Zoning By-law Amendment 01/14 information Spencer Pit

Index

PEER REVIEWS

— projected water table contour (mAMSL)

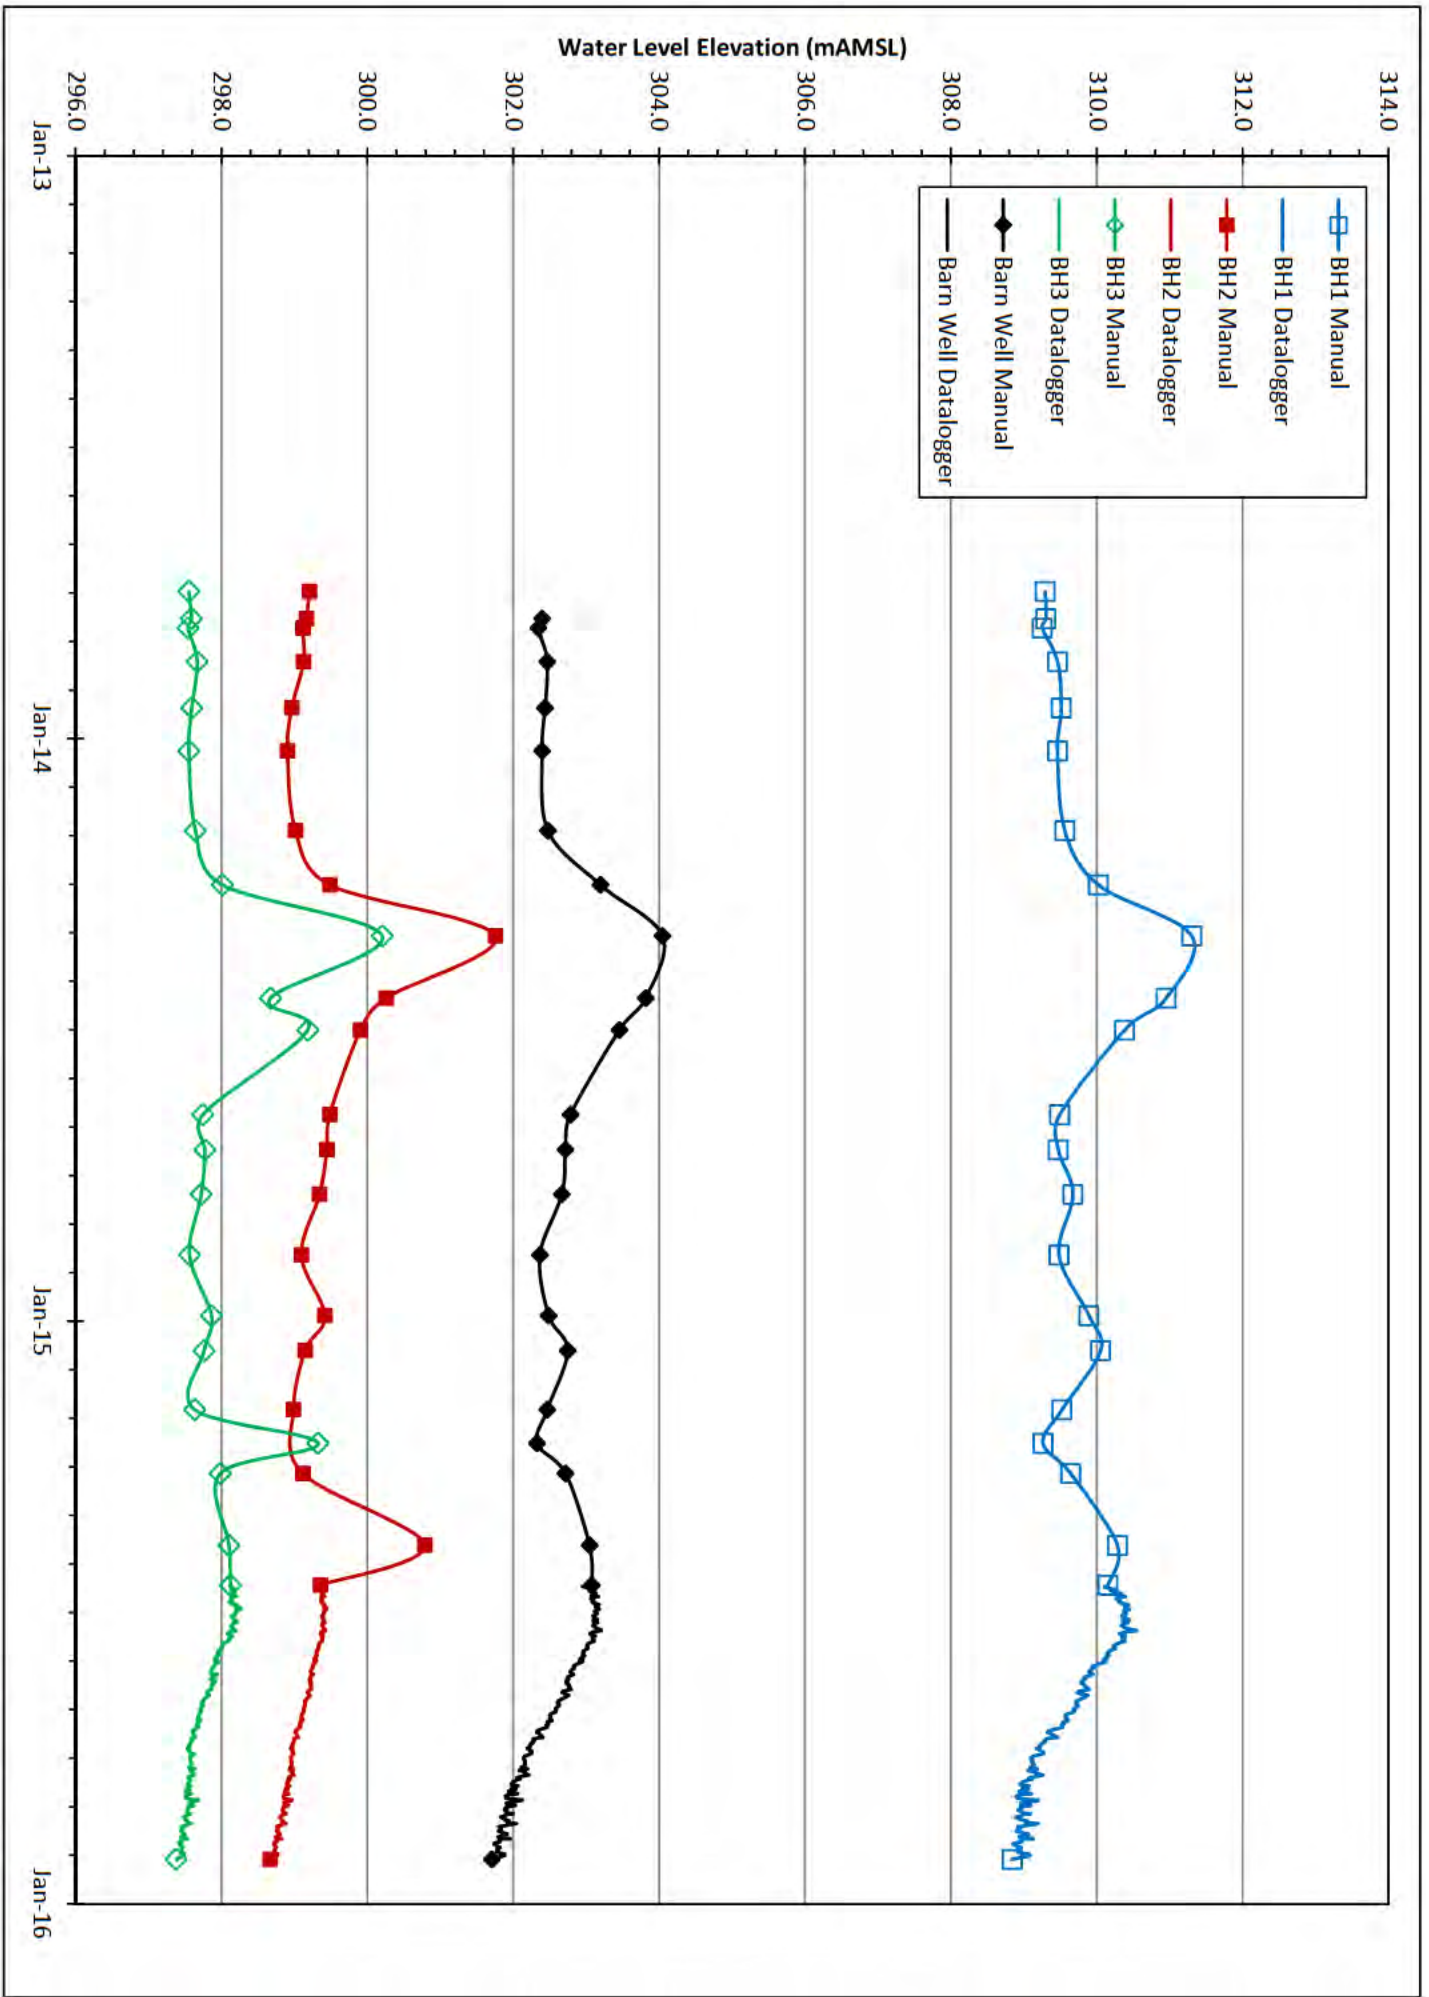
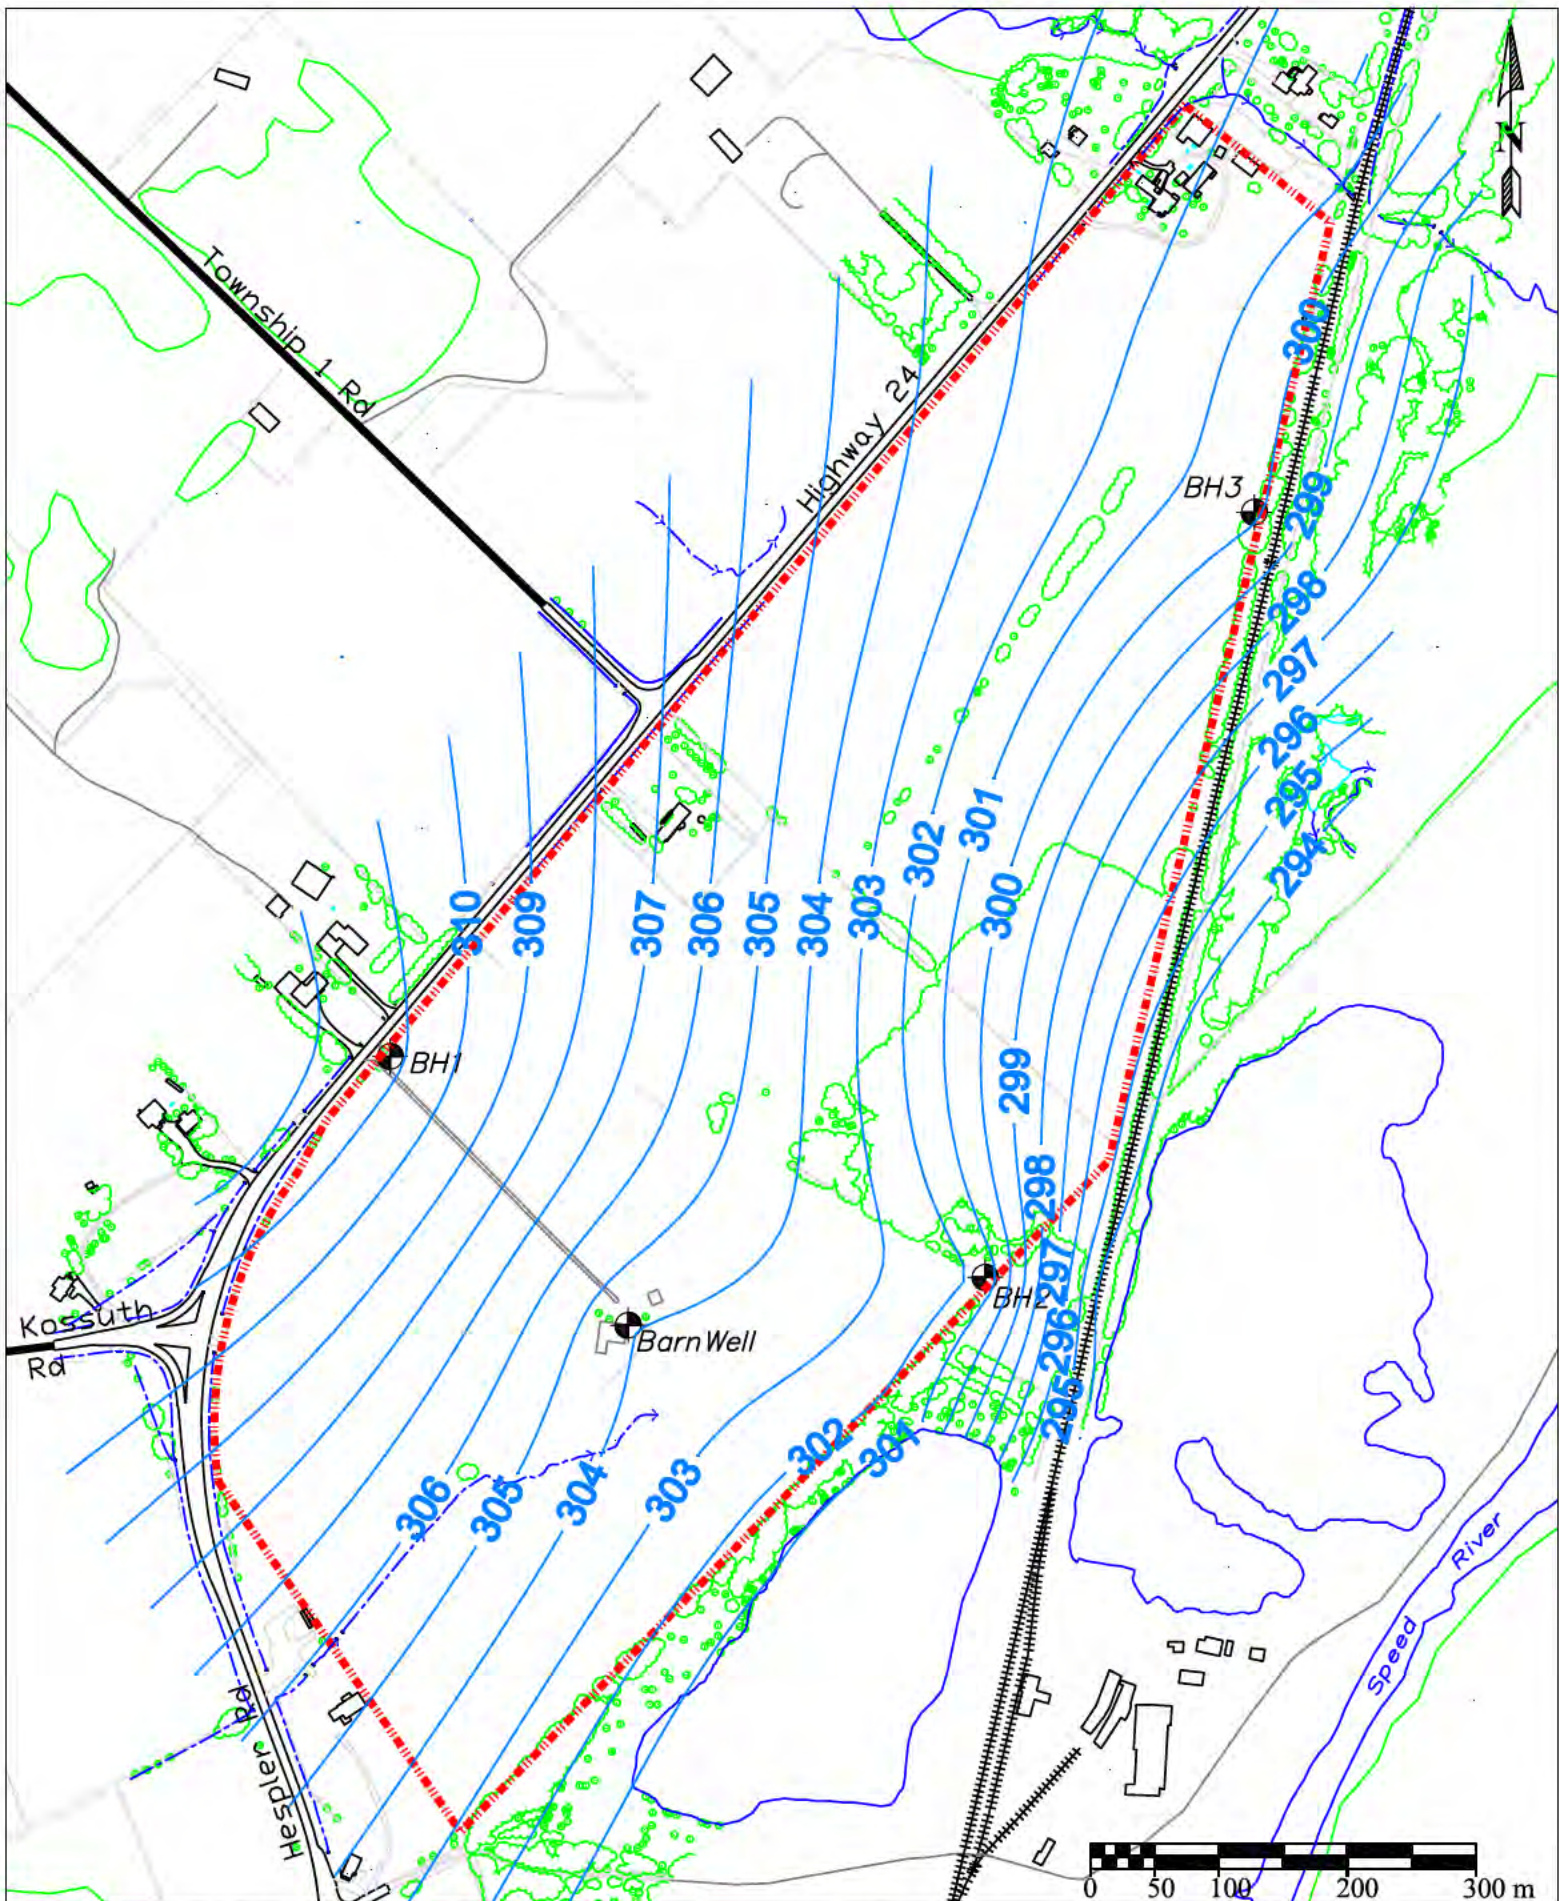
2. This comment is provided in reference to the water levels presented for BH3. Table 2 which summarizes the water level elevations indicates that the water level in this well is in the range of 296.7 while the water level in Figure 4 indicates that the water level is in the range of 298 masl. While this potential error would serve to increase the distance between the water table and the top of bedrock, it is recommended that the water table contours or Table 2 be corrected to reflect this inconsistency.

4. To further support development of the water table elevations and for clarity (and associated mapping on Figure 4 and 5), we recommend the following updates to supporting figures:
 - a. that the highest water table elevation measured since the implementation of the monitoring program be presented.
 - b. the inclusion of the water level measurement used for each monitoring location and the associated bedrock surface elevation as determined from the borehole log could be included along with the Well ID.

In response to review comments provided by others, a geodetic survey of the monitoring locations was completed in July 2014 relative to an MTO elevation monument (station 0011916u87F) located at the site. The updated elevations are as follows:
